**DEVIATION REQUEST
AND DECISION FORM**

Project Name : Eagleview Subdivision
 Schedule No.(s) : 5226000001), 5226000001)
 Legal Description : N2NW4 EX WLY 620.0 FT SEC 26-12-65,S2NW4 EX WLY 620.0 FT SEC 26-12-65

DEVIATION No. 3 - A deviation from the standards of or in Sections **2.3.2 and 2.2.4.A.5** of the Engineering Criteria Manual (ECM) is requested. Please refer to **deviation exhibit 1**. Also attached is **deviation exhibit 2**, which is referenced in the “explanation of the proposed alternative” section below.

Exhibit 1

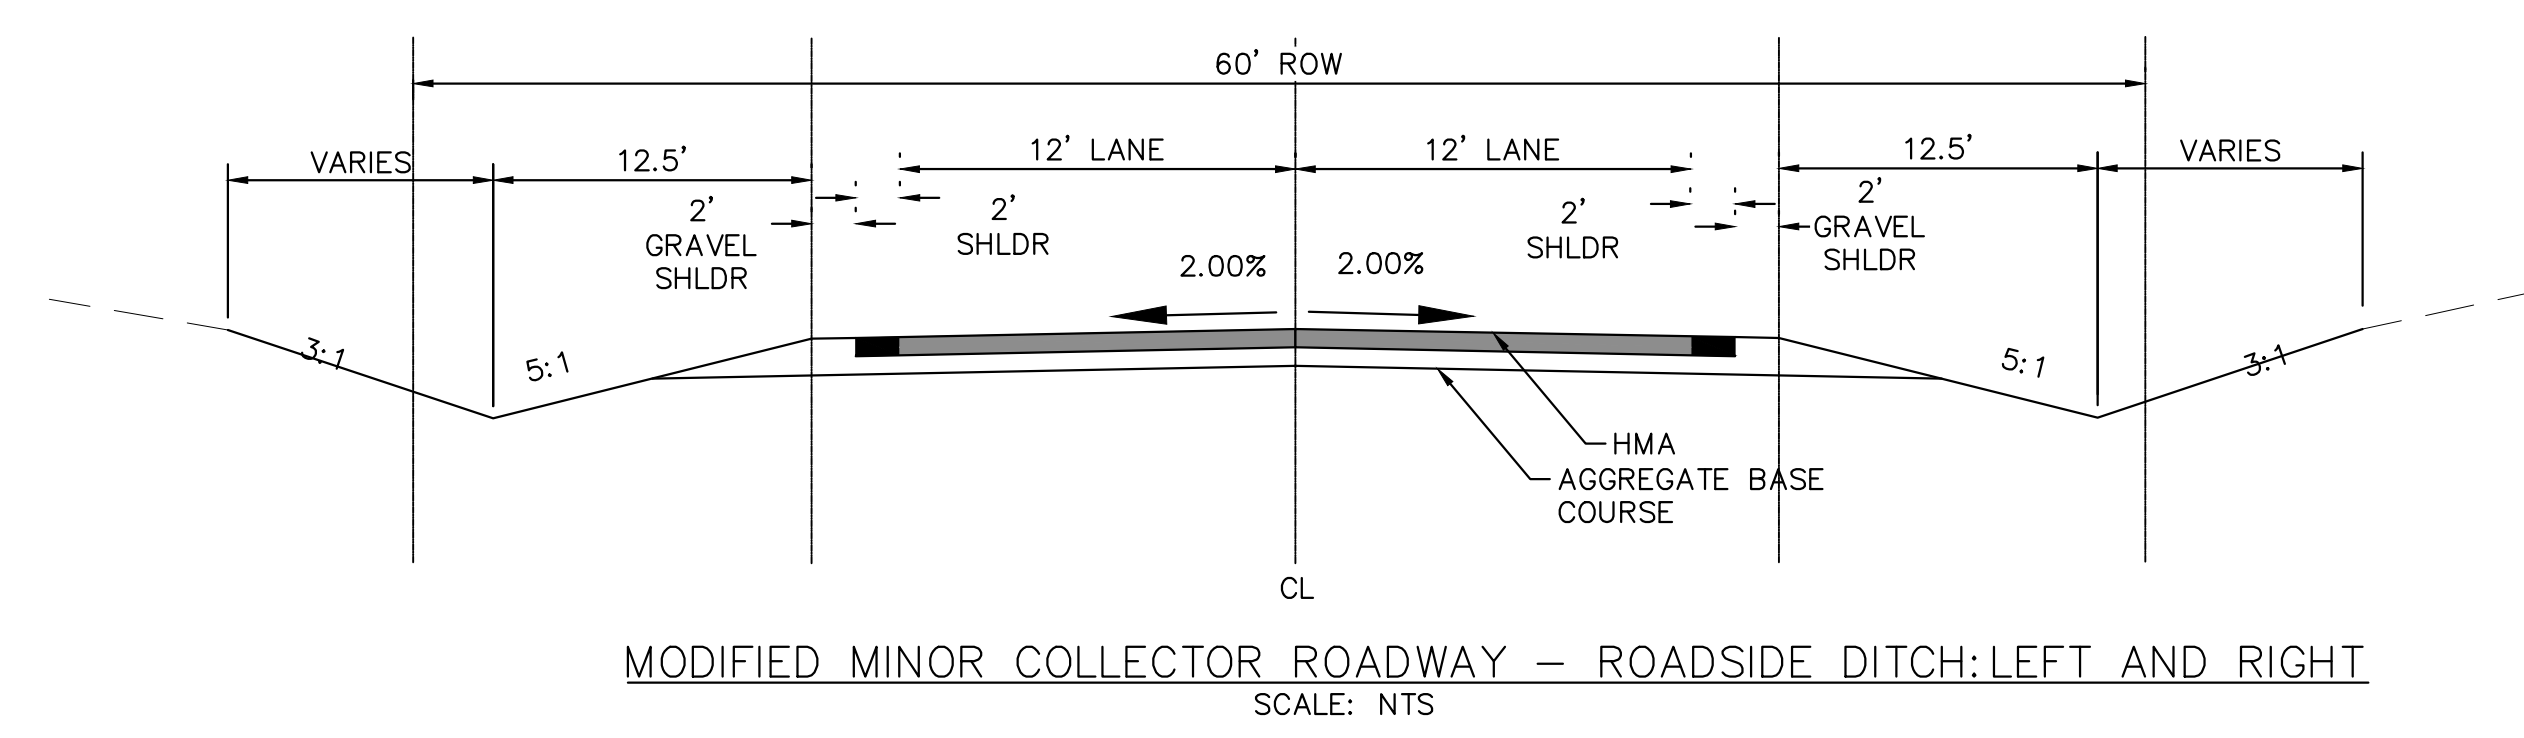
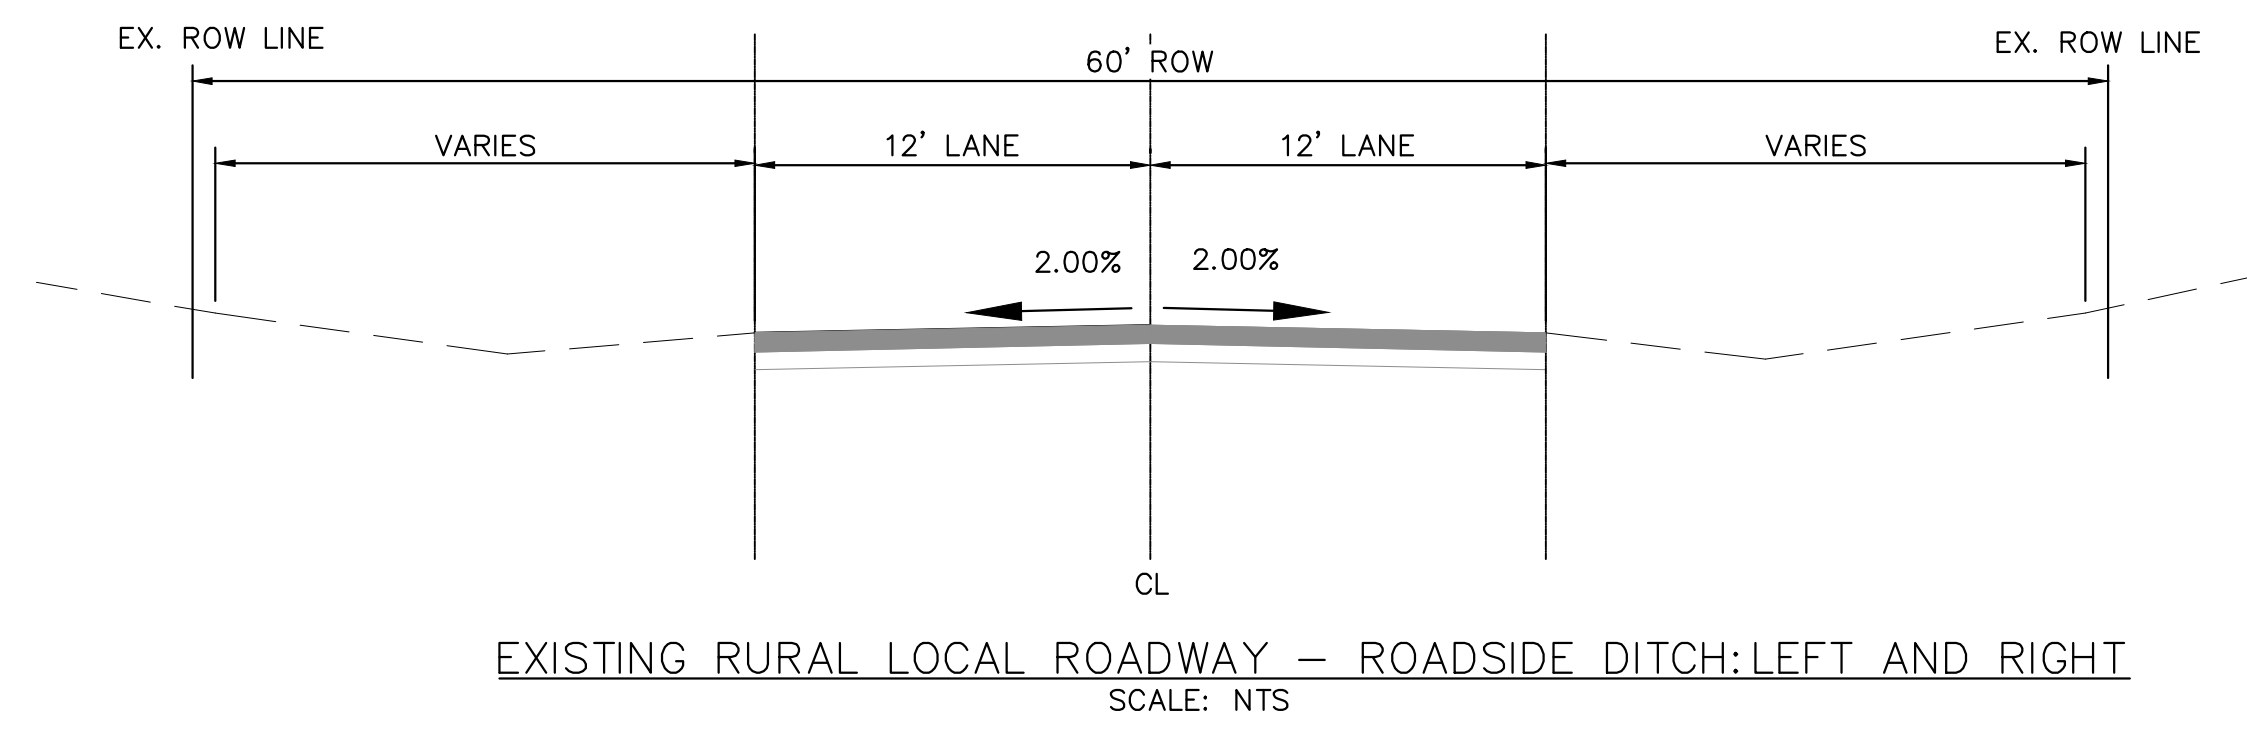
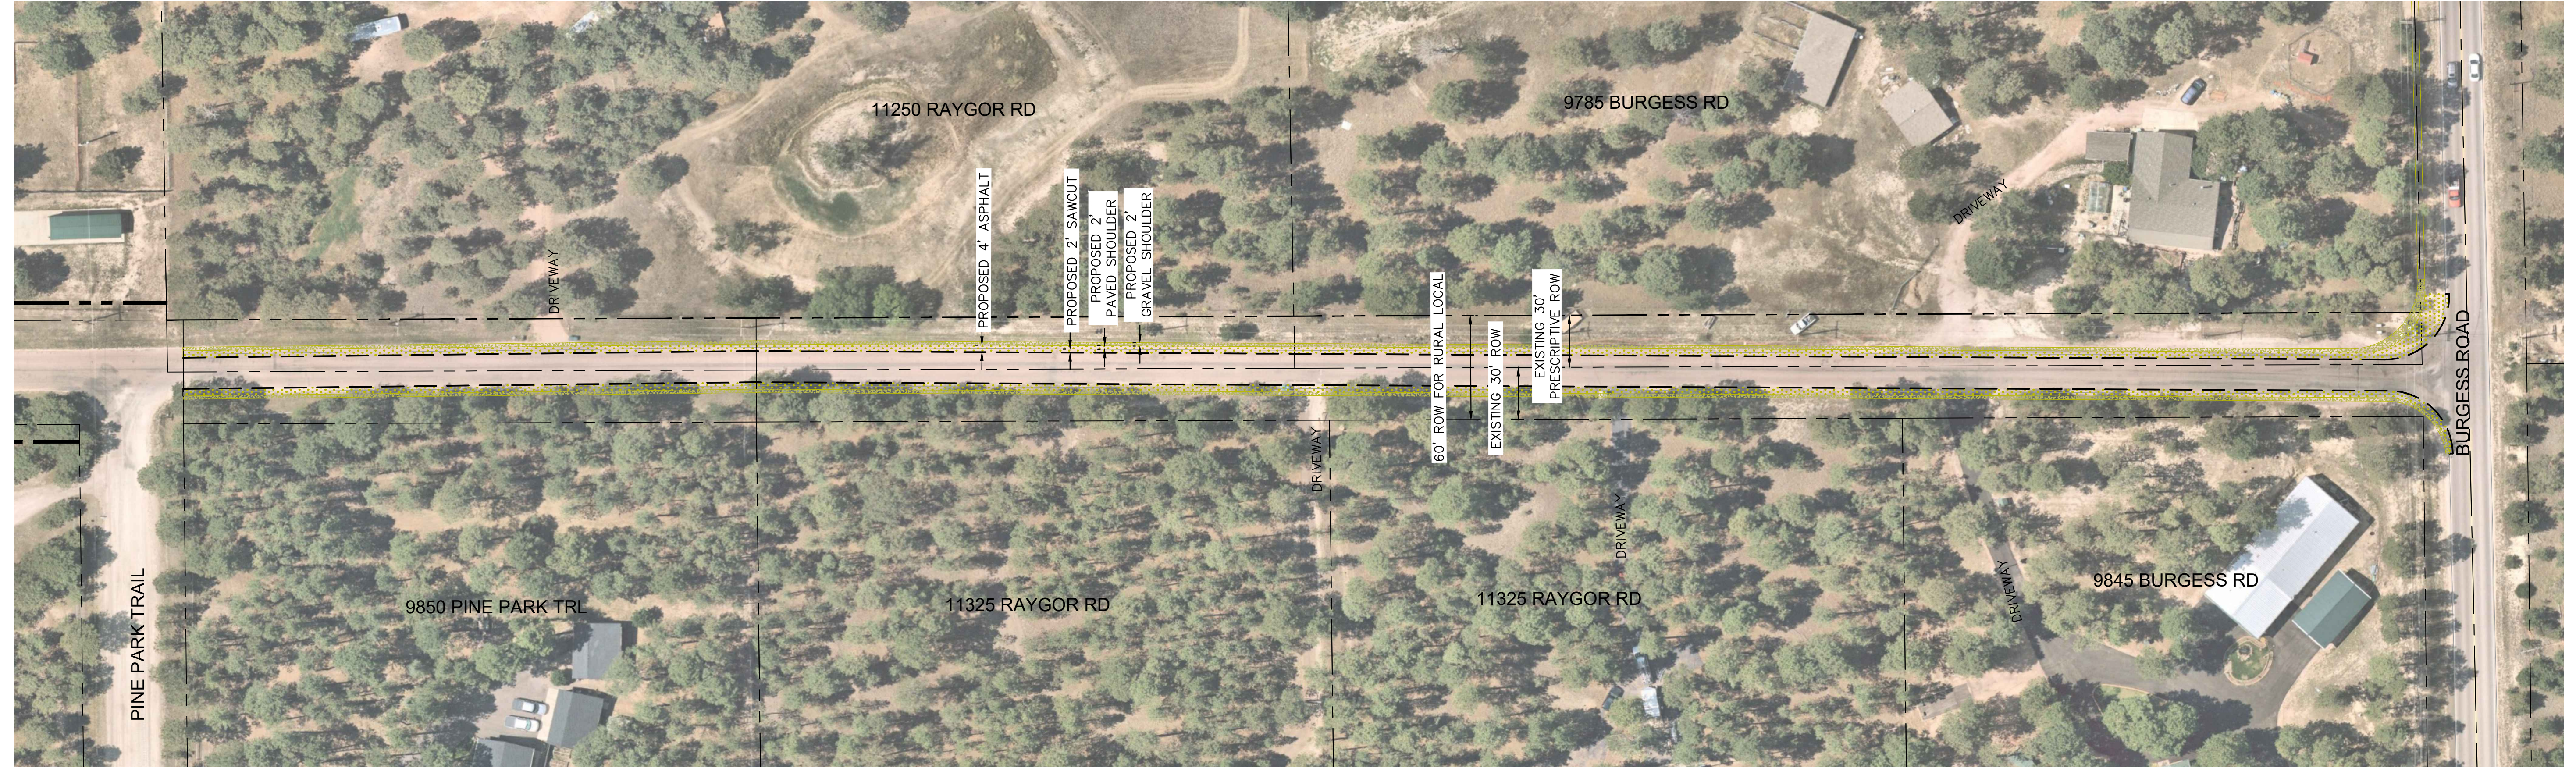
The ADT at the **north end** of Raygor Road is likely within the range of a Rural Minor Collector, currently, even prior to the additional trips estimated for this subdivision. The current Raygor Road ROW and cross section do not meet the ECM standard for a rural minor collector, therefore a deviation is required.

Section of Raygor for which Deviation #3 is requested

Deviation Exhibit 2

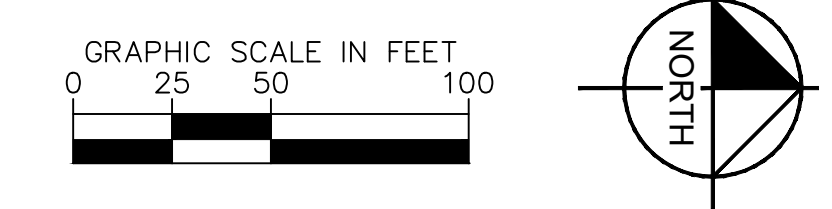
The proposed alternative is to provide an 18-percent fair share of the cost to upgrade Raygor Road to a 28-foot wide paved standard including two-foot paved outside shoulders plus two-foot gravel shoulders. Instead of paying an escrow for the 18 percent of the cost of this improvement, the applicant proposes to complete the improvement on the north end of Raygor between Pine Park Trail and Burgess. **Please refer to deviation exhibit 2**. This is the segment with the highest volume and this construction of a portion in lieu of escrow would put the improved road in-place for the highest volume portion rather than having the funds sit in escrow. The right of way is generally 60-feet. By comparison, the ECM standard Rural Minor Collector cross section has 80-feet of right of way with a 32-foot paved width and 2-foot gravel shoulders (plus roadside ditch sections). The ECM standard pavement section is 3 inches of asphalt over 6 inches of base.

As the current Raygor Road ROW is 60 feet, the Minor Collector cross section would not fit within the existing ROW. The applicant does not control the properties adjacent to Raygor Road. The proposed upgrade to Raygor Road is described above in the “explanation of the proposed alternative” section and depicted in **deviation exhibit 2**.
